Access Compliance Report

Public Rights-of-Way

Intersection ID: 5912	Main Street: BLACK_CHERRY_DR	Cross Street: FOREST_POND_DR	Location: SE
ADA ID: D08C10240F28	Ramp Type: Perp	Initial Pass/Fail: Fail	Overall Compliance: No
Severity Score: 21.25			
Codes/Mitigation Info/Possible Solution		Field Measurements/Component Compliance

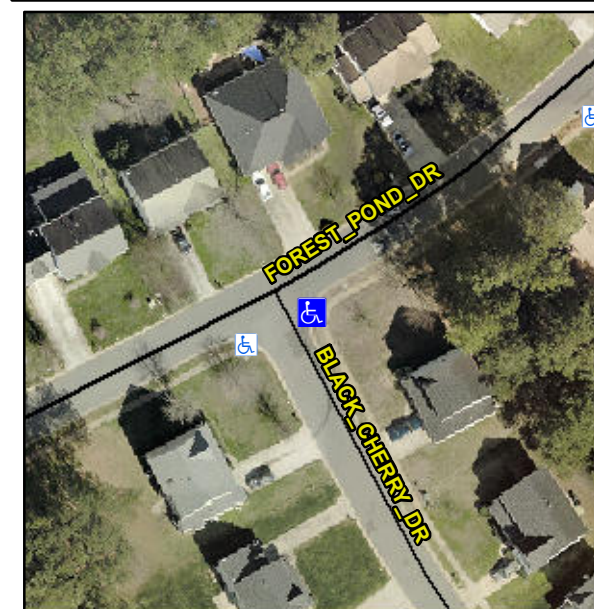
Not Found, R304.5.1, R304.5.3

Compliance	Description	Data	Compliance	Description	Data
N/A	Ramp Length (in)	96.0	Yes	Ramp Slope (%)	6.8
No	Ramp Width (in)	45.0	No	Ramp XSlope (%)	6.6
N/A	Flare Type LT	N/A	N/A	Flare Type RT	N/A
N/A	Flare Slope LT (%)	N/A	N/A	Flare Slope RT (%)	N/A
N/A	Flare Traversable LT?	N/A	N/A	Flare Traversable RT?	N/A
N/A	Landing Length (in)	N/A	N/A	DWS Provided?	N/A
N/A	Landing Width (in)	N/A	N/A	DWS Contrast?	N/A
N/A	Landing Slope (%)	N/A	N/A	DWS Length (in)	N/A
N/A	Landing X Slope (%)	N/A	N/A	DWS Full Width?	N/A
N/A	Landing Curb? (Y/N)	N/A	N/A	DWS Offset (in)	N/A
N/A	Shared Landing?	N/A			
N/A	Gutter Ponding?	N/A	N/A	Gutter Slope (%)	N/A
N/A	Gutter Lip Ht (in)	N/A	N/A	Gutter X Slope (%)	N/A
N/A	Painted X Walk1?	No	N/A	Painted X Walk2?	N/A
	X Walk 1 Direction	To W		X Walk 2 Direction	N/A
N/A	X Walk 1 Width (in)	N/A	N/A	X Walk 2 Width (in)	N/A
	X Walk 1 Slope (%)	0.1		X Walk 2 Slope (%)	N/A
	X Walk 1 X Slope (%)	6.2		X Walk 2 X Slope (%)	N/A

Remove & Replace Entire Ramp.
